Sustainer Boat tail

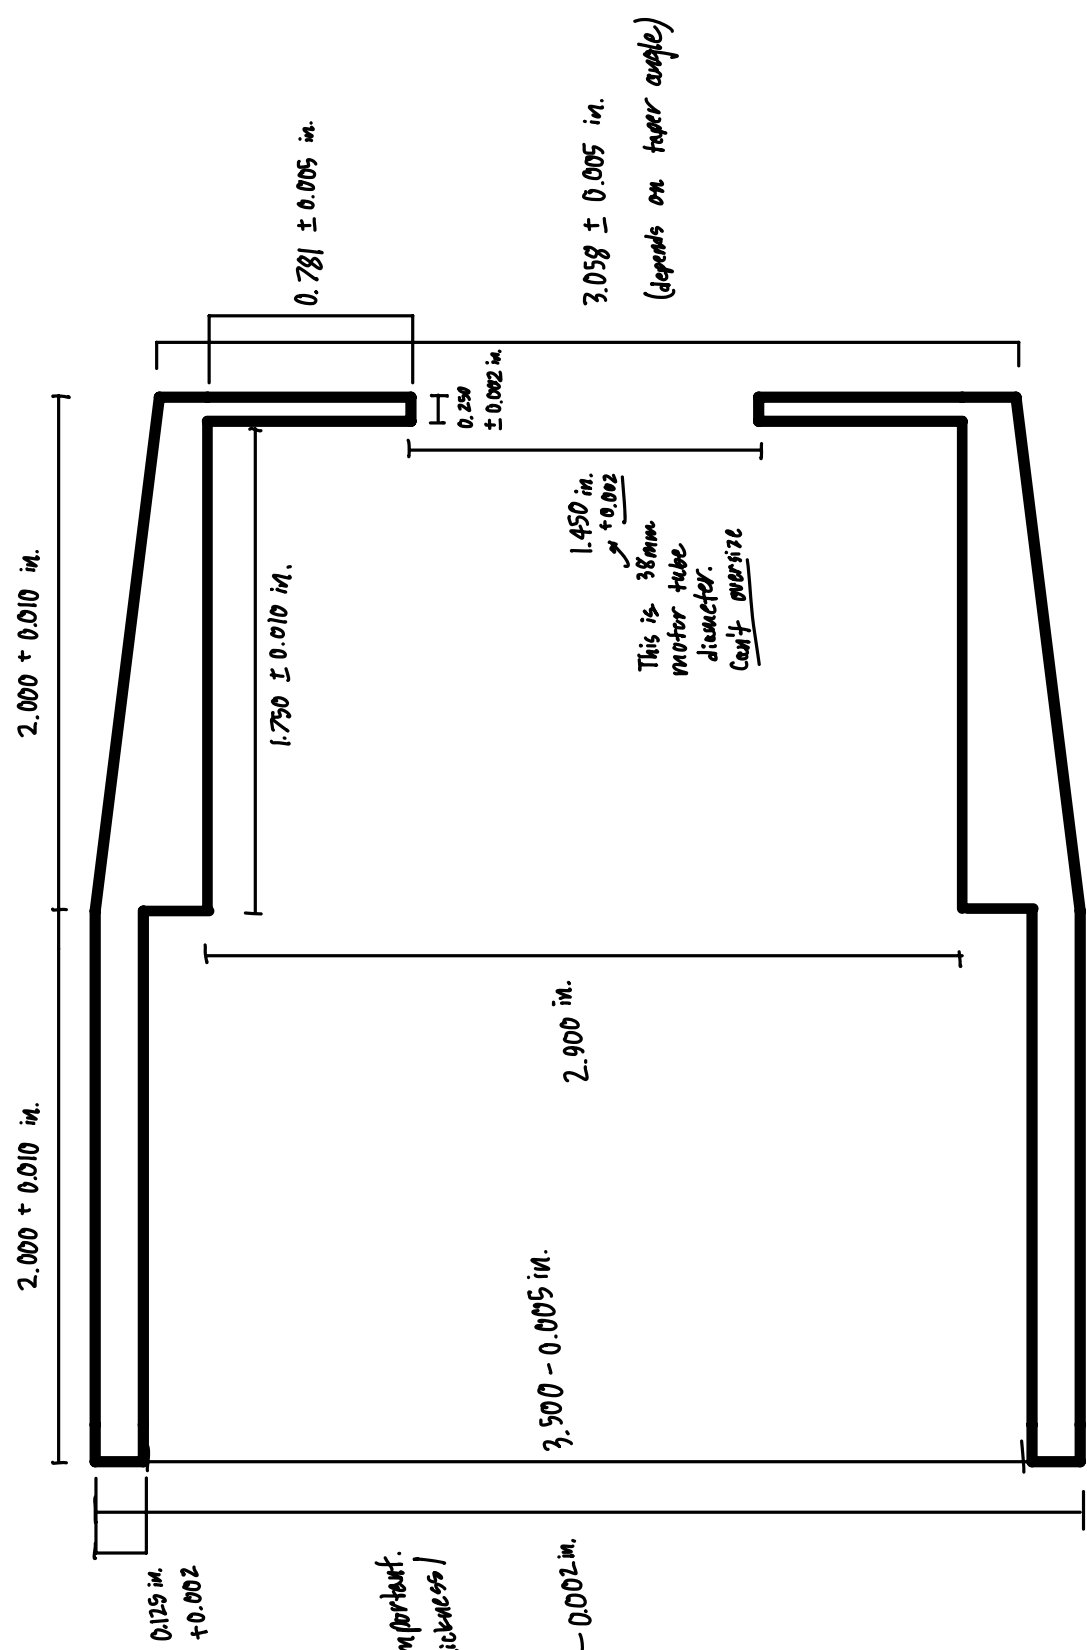
CNC slightly small. We can ID to reach final thickness.

This is really important.
 It affects ABC wall thickness / structure.

This is 38mm motor tube diameter.
 Can't oversize

CNC 2 + $\frac{1}{16}$ in. bore
Current stock length: 8 + $\frac{1}{32}$ in.
Need to face down to: 7.125 in.
